Access Compliance Report Public Rights-of-Way (Curb Ramps)

Main Street: MAUVE_DR Cross Street: 17TH_ST Location: NE

ADA ID: RPRK211007152017 Ramp Type: Type 1 - Perpendicular Diagonal Initial Pass/Fail: Fail Overall Compliance: No Severity Score: 15

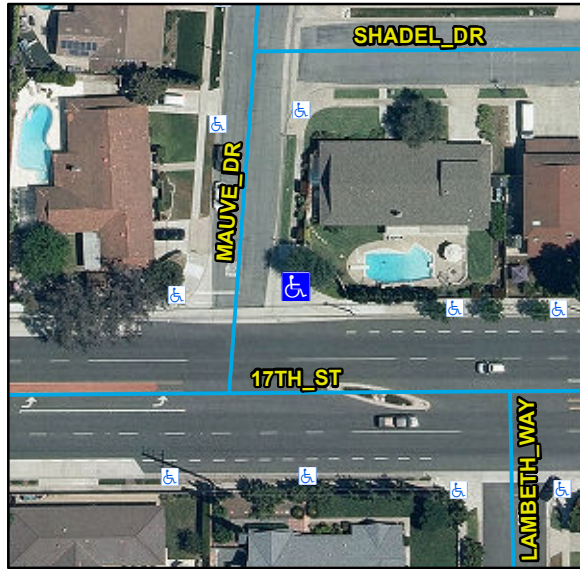
Compliance	Description	Data	Compliance	Description	Data
N/A	Ramp Length (in)	93	N/A	Flare Type LT	
Yes	Ramp Width (in)	48			N/A
No	Ramp Run Slope (%)	9.8	N/A	Flare Slope LT (%)	N/A
Yes	Ramp Cross Slope (%)	1.4	N/A	Flare Traversable LT	N/A
N/A	Landing Present	N/A	N/A	Flare Type RT	
N/A	Landing Length (in)	N/A			N/A
N/A	Landing Width (in)	N/A	N/A	Flare Slope RT (%)	N/A
N/A	Landing Run Slope (%)	N/A	N/A	Flare Traversable RT	N/A
N/A	Landing Cross Slope (%)	N/A	N/A	DWS Provided	N/A
N/A	Landing Movement Obstructed?	N/A	N/A	DWS Contrast	N/A
	Landing Movement Type	N/A	N/A	DWS Length (in)	N/A
N/A	Landing Shared	N/A	N/A	DWS Full Width	N/A
N/A	Clear Space	Yes	N/A	DWS Offset Left (in)	N/A
N/A	Clear Space To Crosswalk (in)	N/A	N/A	DWS Offset Right (in)	N/A
N/A	Marked Crosswalk 1	No	N/A	Marked Crosswalk 2	No
	Crossing 1 Direction	W		Crossing 2 Direction	S
	Marked Crosswalk 1 Width (in)	N/A		Marked Crosswalk 2 Width (in)	N/A

N/A	Ramp Inside Crosswalk 1	N/A	Yes	Ramp Inside Crosswalk 2	N/A
	Crossing 1 Slope (%)	8.7		Crossing 2 Slope (%)	3.9
	Crossing 1 Cross Slope (%)	2.4		Crossing 2 Cross Slope (%)	1.1
N/A	Gutter Ponding	N/A	No	Curb Slope	12.9
Yes	Gutter Lip Height (in)	0		Road Run Slope (%)	2.2
N/A	Gutter Run Slope (%)	N/A		Road Cross Slope (%)	8.3
N/A	Gutter Cross Slope (%)	N/A			
Yes	Overall Surface Condition: Acceptable		Yes	Perp Joint Present	Yes
	Cross Gutter Present?	Yes		Spandrel Present?	Yes
	Replace Cross Gutter?	No		Replace Spandrel?	No

Remove & Replace Curb Ramp With Two New Directional Ramps or Equivalent.

R304.2.2, STD 1115
